PELICAN'S LANDING SUBDIVISION

APPLICATION NUMBER 18 DATE December 4, 2003
APPLICANT Pelican's Landing Subdivision
REQUEST Subdivision

PELICAN'S LANDING SUBDIVISION

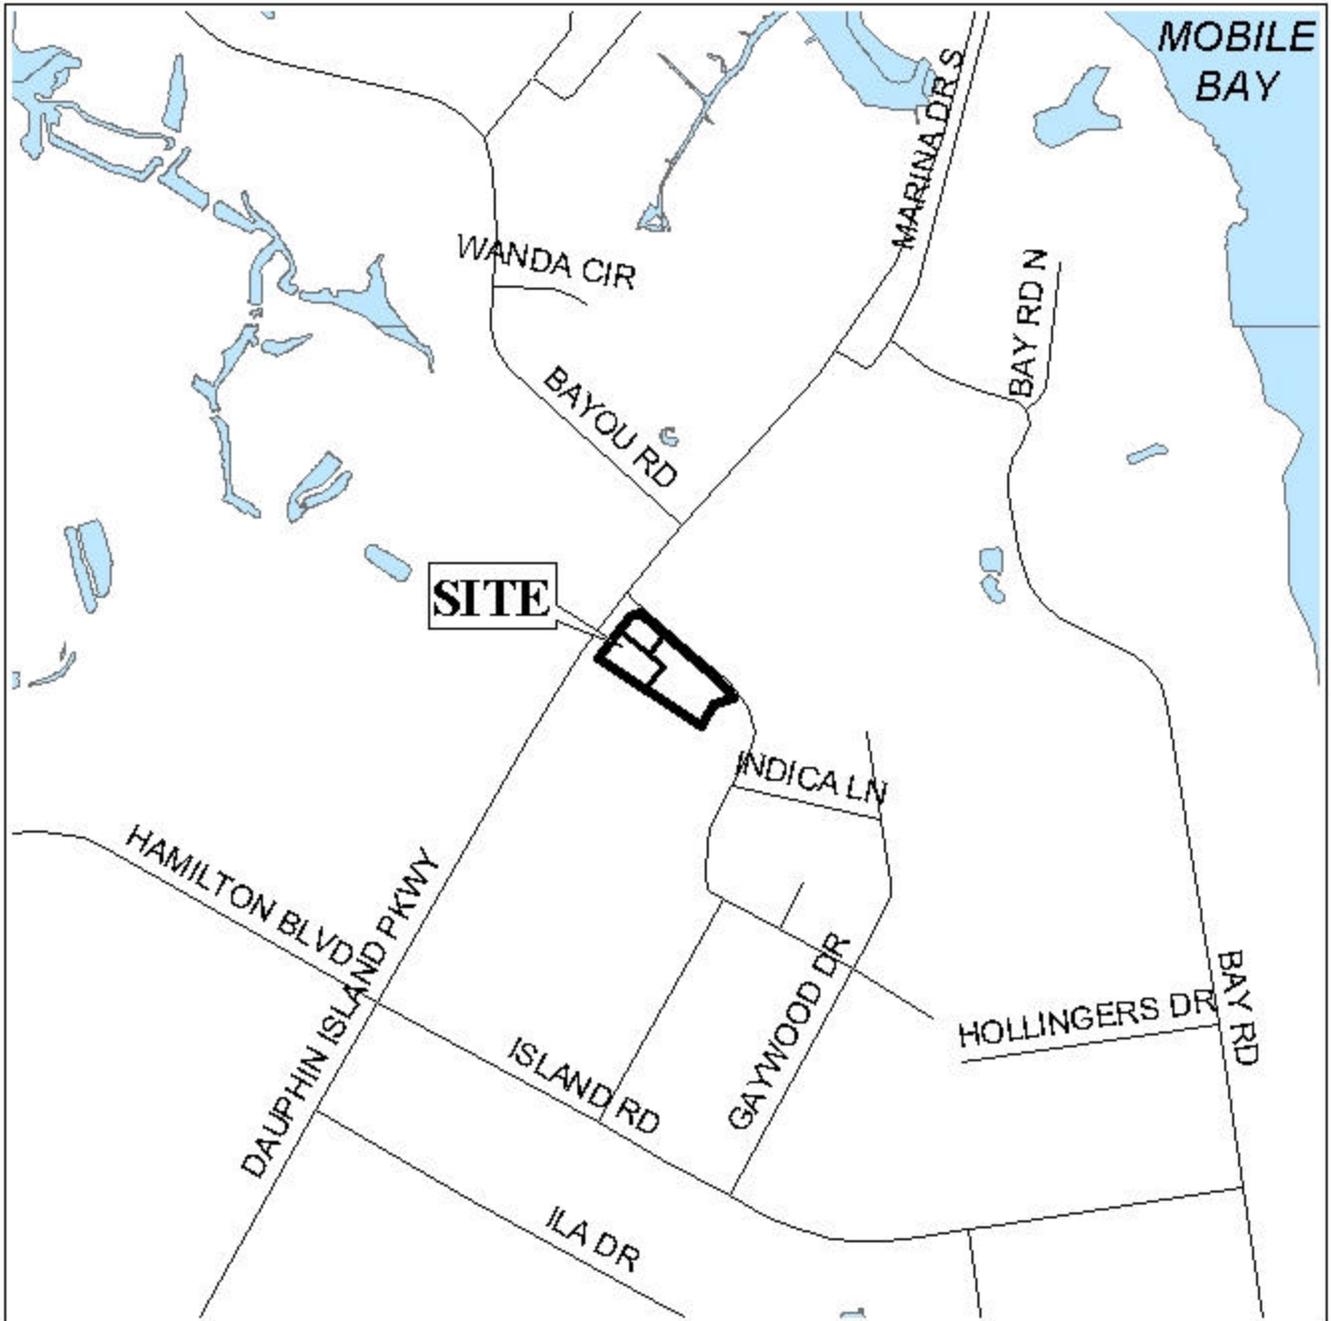
The site fronts Dauphin Island Parkway, which is a planned major street and has an existing right-of-way in compliance with the Major Street Plan. However, as a means of access management, the placement of a note on the final plat stating that Lots 1 and 2 are limited to one curb cut each to Dauphin Island Parkway, with the size, location and design to be approved by County Engineering, should be required. Additionally, the placement of a note on the final plat stating that Lot 3 is limited to one curb cut, in the northwestern part of the lot, with the size, location and design to be approved by County Engineering, should be required.

As indicated on the Vicinity Map, the site is located in the 100-year floodplain and as such the area may be considered environmentally sensitive; therefore, the approval of all federal, state and local agencies would be required.

This site is located in the County, thus a note should be placed on the final plat stating that any lots which are developed commercially and adjoin residentially developed property must provide a buffer, in compliance with Section V.A.7. of the Subdivision Regulations.

The twenty-five foot minimum setback lines are not shown but would be required on the final plat.

With modifications, the plat will meet the minimum requirements of the Subdivision Regulations and is recommended for Tentative Approval subject to the following conditions: 1) the placement of a note on the final plat stating that Lots 1 and 2 are limited to one curb cut each to Dauphin Island Parkway, with the size, location and design to be approved by County Engineering; 2) the placement of a note on the final plat stating that Lot 3 is limited to one curb cut in the northwestern part of the lot, with the size, location and design to be approved by County Engineering; 3) the developer obtain any necessary approvals from all applicable federal, state and local agencies prior to the issuance of any permits; 4) placement of a note on the final plat stating that any lots which are developed commercially and adjoin residentially developed property must provide a buffer, in compliance with Section V.A.7. of the Subdivision Regulations; and 5) placement of the required 25-foot minimum setback lines on the final plat.
